| 02-2017 LATEST REVISION DATE <i>Norman E. Mc Donald</i> APPROVED BY BRIDGE ENGINEER | | |
| | STANDARD DESIGN - 40' ROADWAY, 3 SPAN BRIDGES ROLLED STEEL BEAM BRIDGES OCTOBER, 2014 | |
| | JUNCTION BOX AND CONDUIT DETAILS SHEET 2 | RS40-092-14 |

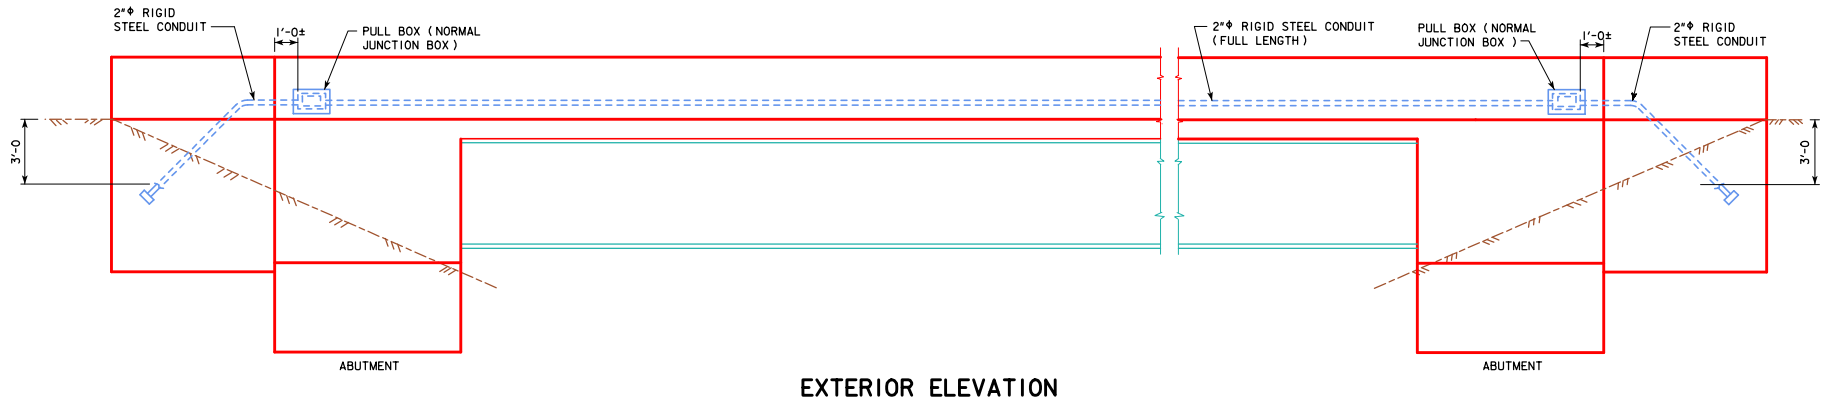
REVISED 02-2017 - REMOVED ALL CONDUIT, JUNCTION BOX DETAILS AND LIGHTING NOTES, ADDED NOTES STATING "SEE STANDARD SHEET 1030As1 AND 1030As2 FOR JUNCTION BOX DETAILS AND LIGHTING NOTES, REINFORCING AND DETAILS REGARDING REINFORCING AND THE PLACEMENT OF CONDUIT AND JUNCTION BOXES IN BARRIER RAILS WITH STAINLESS STEEL REINFORCING".

NOTE: SEE STANDARD SHEET 1030As1 FOR LI-104 JUNCTION BOX DETAILS AND LIGHTING NOTES.

NOTE: SEE STANDARD SHEET 1030As2 FOR REINFORCING AND DETAILS REGARDING THE PLACEMENT OF CONDUIT AND JUNCTION BOXES IN BARRIER RAILS WITH STAINLESS STEEL REINFORCING. (SECTION THRU BARRIER RAIL, JUNCTION BOX AND PART PLAN AT WING).
